Re: Proposed development of Healy Corner, 195 Tahattawan Rd

To the Town of Littleton Planning Board,

Figure A (Current Density Yield Plan)

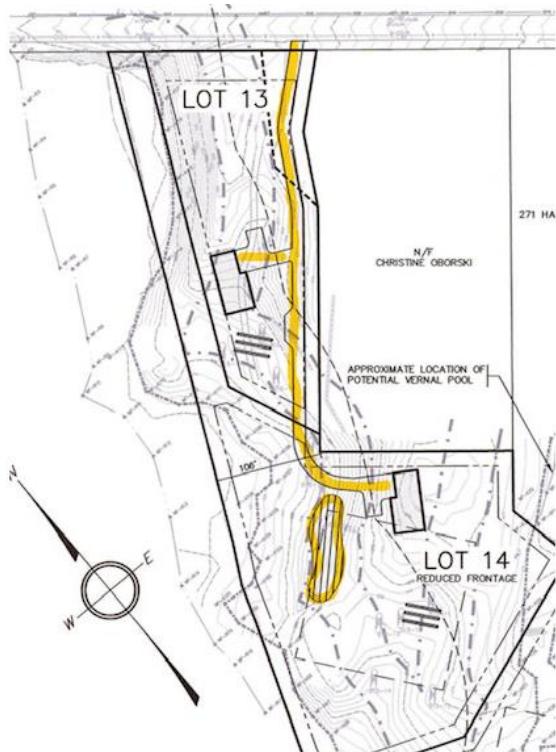
We are writing to voice a concern with the proposed subdivision at 195 Tahattawan Rd (Healy Corner). We own the property at 269 Harwood Avenue, and we are concerned about the proposed driveway to lots 13 and 14 as drawn on the Density Yield Plan. We have attached a copy of this portion of the latest plan for reference (Fig. A).

The current plan shows a shared driveway for lots 13 and 14 constructed directly through the easement area. It is our understanding that, per MA law regarding overburdening an easement, driveway access to lots 13 and 14 must be outside of this designated area. It is also our understanding that if the developer proposes to have our driveway become a shared 3-way driveway with lots 13 and 14, then this would require a special permit, which is not allowable for the Density Yield Plan to be accepted by the Board. It is also our understanding that the existing easement protects us from this possibility.

Furthermore, the shared driveway for lots 13 and 14 is currently drawn extending along the entire border of our property. In reality, this is an area of steep decline and it seems likely that significant regrading of the entire western side of our property would be required for the placement of this proposed driveway. It is our understanding that this is also not allowable per Littleton bylaw. This point has been raised in a recent correspondence from the Conservation Trust that is posted on the Healey Corner project page as well. (Littleton Conservation Trust Comments April 17 2020).

Figure C (wetlands location in Lot 13 and 14)

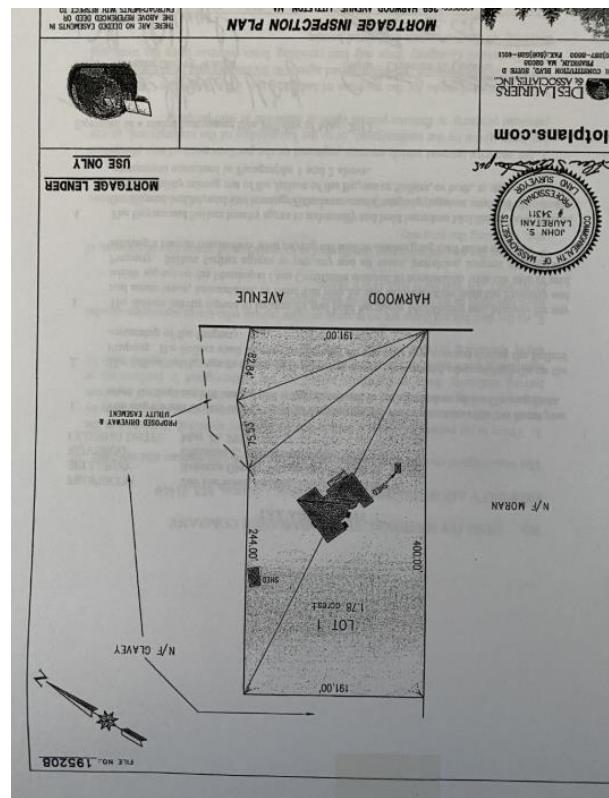
This area of the development is heavily covered in wetlands and changing topography. We have attached for reference a copy of the development plan colored to illustrate the presence of the wetlands as it relates to the proposed driveway for lots 13 and 14 (Fig. C and D). In these figures, the wetlands are colored red, the 50' buffer zone to the wetlands is colored orange, and the existing driveway easement is colored blue. It is our belief that the developer needs to be able to demonstrate the ability to access Lots 13 and 14 taking into consideration the wetlands, buffer zone, easement, and steep topography in the area alongside the shared border and Harwood Ave. We do not believe this is currently being met and request further review of the issue.
